**SUBJECT:** **NEW VEHICLE DEMONSTRATION / DELIVERY HOLD**  
**Customer Satisfaction Program 20B14 – Supplement #1**  
Certain 2020 Model Year Escape Full Hybrid Electric Vehicle  
Powertrain Control Module Update

**NEW VEHICLE DEMONSTRATION / DELIVERY HOLD  
Customer Satisfaction Program 20B14 – Supplement #1  
Certain 2020 Model Year Escape Full Hybrid Electric Vehicle  
Powertrain Control Module Update**

## CERTAIN 2020 MODEL YEAR ESCAPE FULL HYBRID ELECTRIC VEHICLE — POWERTRAIN CONTROL MODULE REPROGRAM

**FIGURE 1**

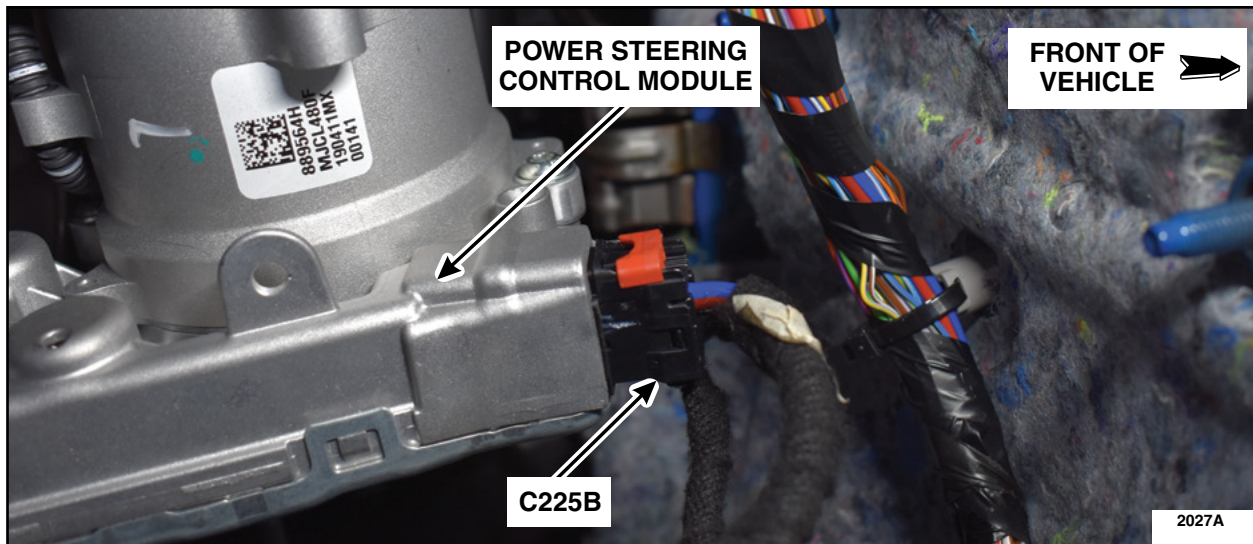
- 1. Disconnect C225B at the Power Steering Control Module (PSCM) prior to installing the battery charger. To disconnect C225B pull back on the red locking tab, press down on the tang and then pull the connector housing straight out. C225B will remain unplugged during the programming procedure. See Figures 1 and 2.*

**10. Connect and lock the red tab of C225B to the PSCM. See Figures 1 and 2.**
